INDESIT company

AQSD129EU/HA

F051197

1290120 Exploded views

1290210 Exploded views

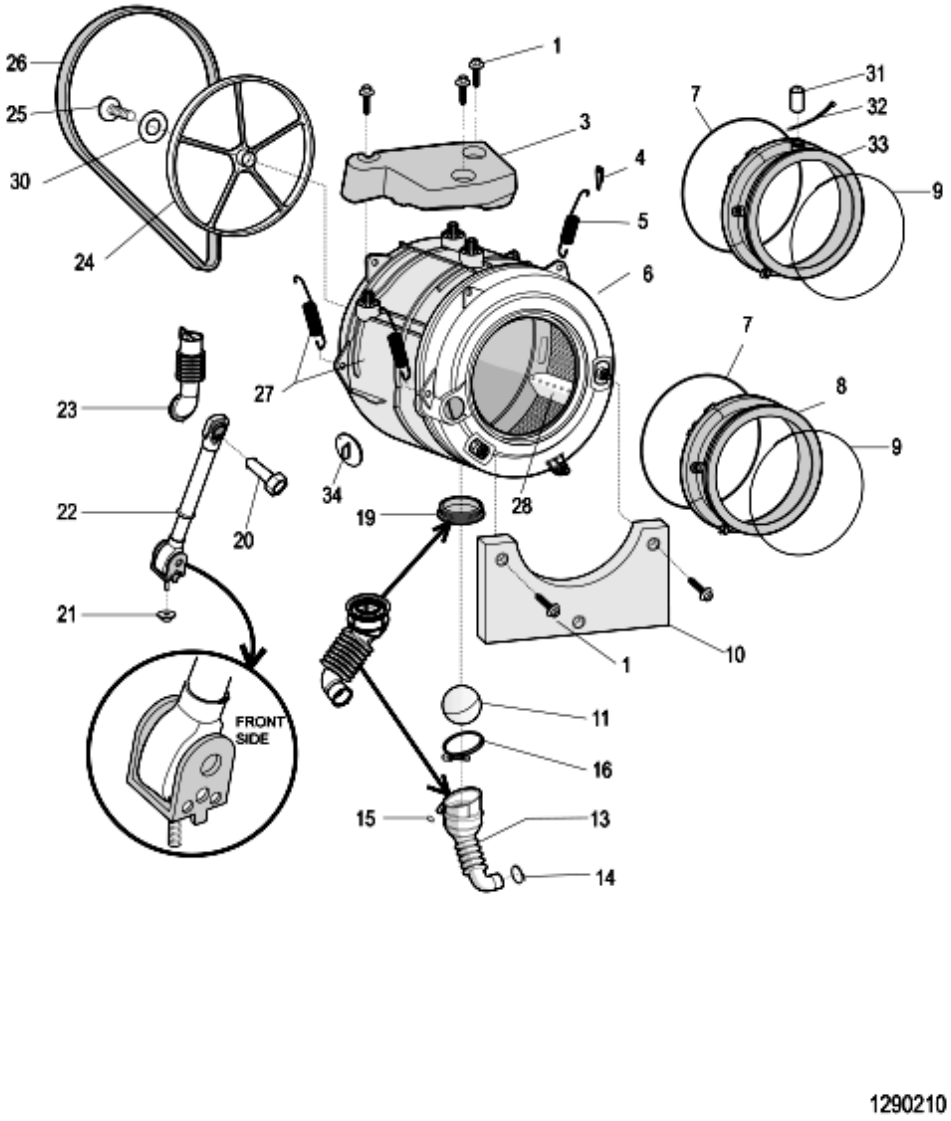
n4011c00: Counterweight screws

Use code C00194612 (screw with larger diameter) in case of fixing counterweight on the original plastic tub of the machine

Use code C00194611 in case of fixing counterweight on a new plastic tub used as spare part

NOTE:
When /if replacing the Plastic outer drum assembly ensure the correct counterweight screws are used.

n4008f00: Thermic link wire removed on three-phase motor

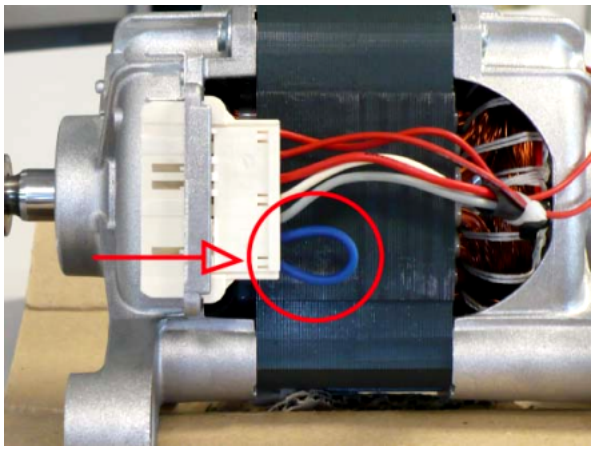
Attention!
When you assist the premodification models using the new motor code you MUST use the thermic link wire code C00265838.

The spare part warehouses will manage the premodification motor until the end of the stock, after they will be replaced with new ones and thermic link wire.

TRIPHASE P40 46 L – INOX TUB
C00265827 new motor without thermic link wire - C00116103 premodification motor with thermic link wire

TRIPHASE P40 46 L – PLASTIC TUB
C00265826 new motor without thermic link wire - C00142390 premodification motor with thermic link wire

TRIPHASE P50 52 L
C00265829 new motor without thermic link wire - C00142205 premodification motor with thermic link wire

TRIPHASE P32 46 L TOP LOADING
C00265832 new motor without thermic link wire - C00262375 premodification motor with thermic link wire

TRIPHASE P40 46 L TOP LOADING
C00265834 nuovo new motor without thermic link wire - C00112739 premodification motor with thermic link wire

In the attached image you can see the fixing of thermic link wire in the motor therminal box.
